REPORT TO COUNCIL

Application: DP17-0068 & DVP17-0069 **Owner:** Summerwood Retirement Resort Holding Corporation, INC. No. BC1090350

Address: 1360 KLO Road **Applicant:** Kent-Macpherson

Subject: Development Permit & Development Variance Permit Applications

Figure 1 – The area noted in red indicates the requested side setback variance from 7.0 m required to 4.5 m proposed.

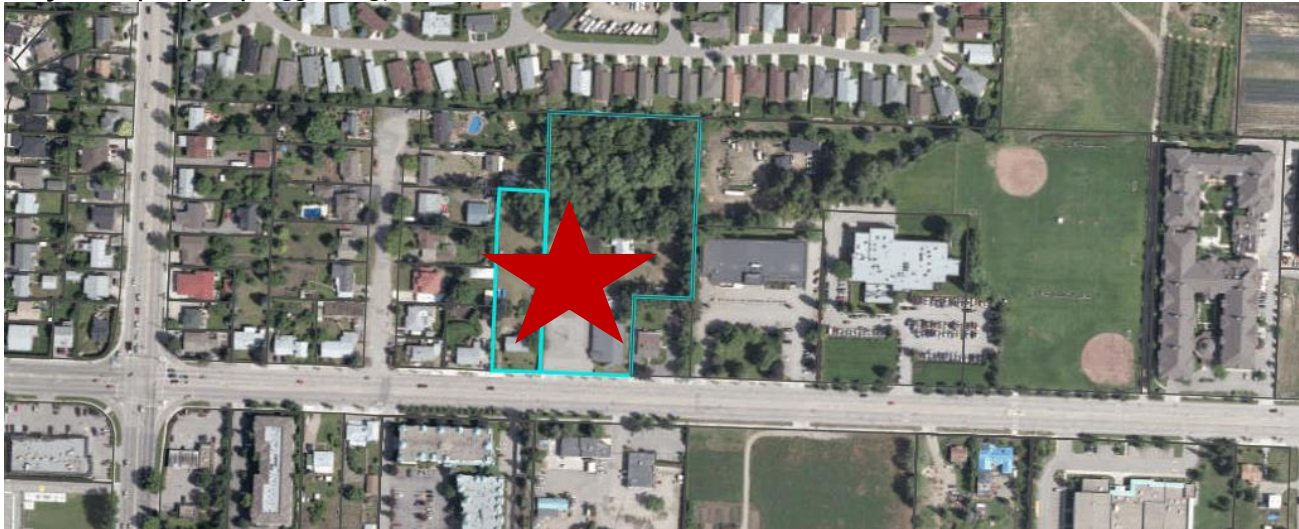
The second variation is to reduce the east side setback for portions of a building over 2 ½ storeys from 7.0 m required to 4.5 m proposed. The project has been designed such that in the future, should the property located at 1390 KLO Road (outlined in blue) become available, the proposed development could extend the building south towards KLO Road. In the meantime, the applicant is requesting a variance to reduce the side setback, for that portion of the property line which is shared with the rear of the 1390 KLO Road property. The area of the variance is indicated in red.
